## UPDATE REPORT

BY THE DIRECTOR OF ECONOMIC GROWTH AND NEIGHBOURHOOD SERVICES READING BOROUGH COUNCIL PLANNING APPLICATIONS COMMITTEE: 13 January 2021	ITEM NO. 8
--	------------

Application Nos.: 192032/HYB, 200822/NMA, 200823/NMA, 190441, 190442

Address: Station Hill, Reading

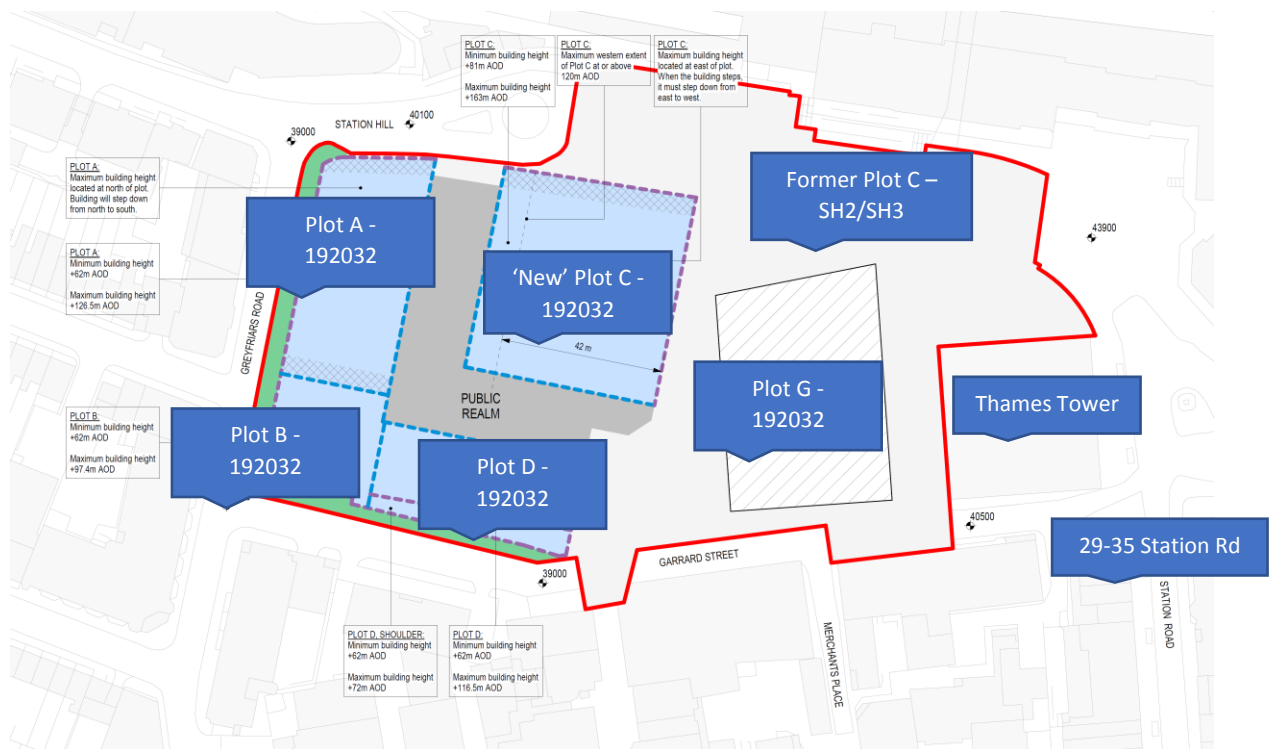
- 2.2 It is considered that it would be useful to provide further clarification on the heights of the proposed buildings (maximum heights in the case of Phase 3) and to compare these with existing tall buildings in the area and those which have been granted permission but not built.

- 2.3 The chart above is intended to give an indication of the heights of tall buildings in the area, with the existing/previously permitted buildings to the left and compared with the current Station Hill proposals to the right. The levels quoted are heights above mean sea level (AOD). To reflect the way the buildings might appear 'on the ground' the scale has been set beginning at 40m AOD, this is because the surrounding street levels range between 38.7m AOD at the junction of Garrard St and Greyfriars Road and 44m AOD at the station entrance in Station Square.

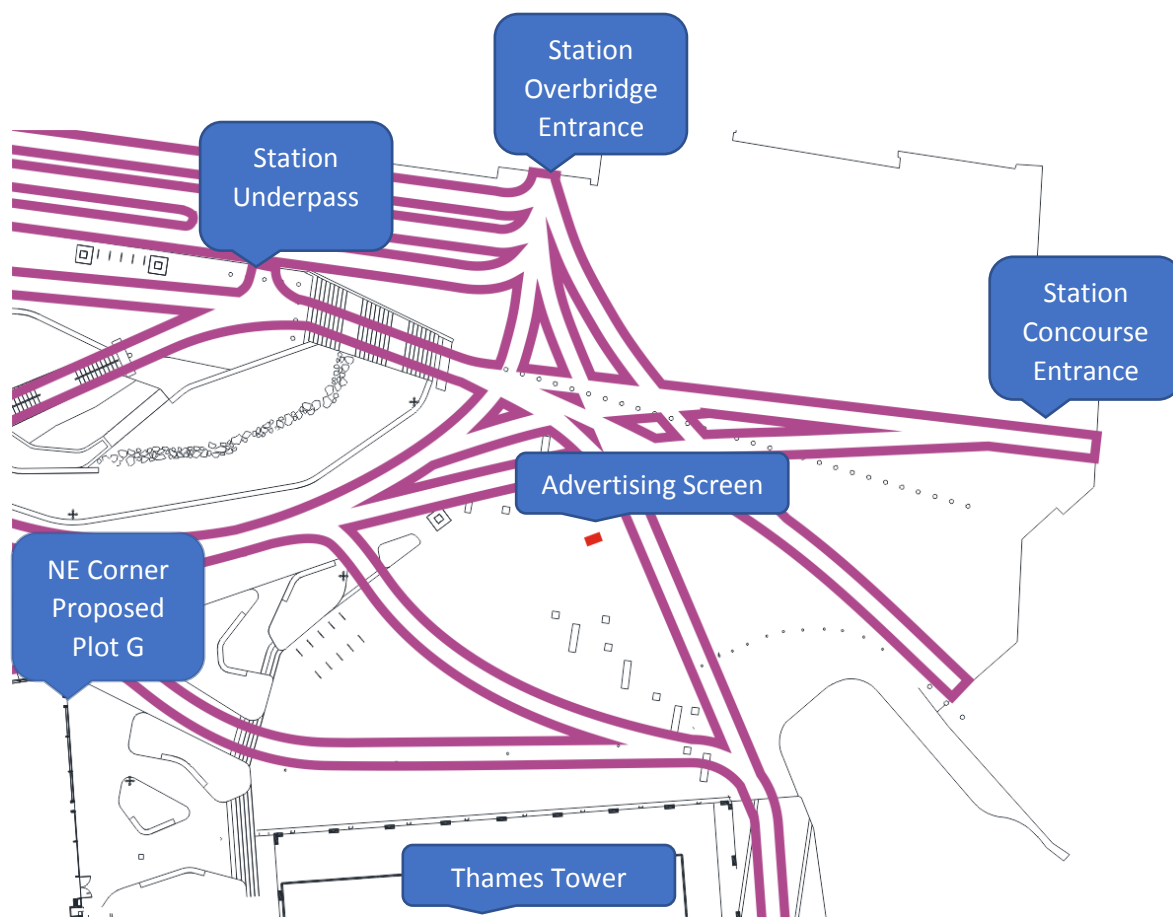
- 3.1 The image below appears in the Transport Comments para 4.4 of the main report.
- 3.2 It is noted that the image is not labelled which may cause some confusion. Location labels are now included below:
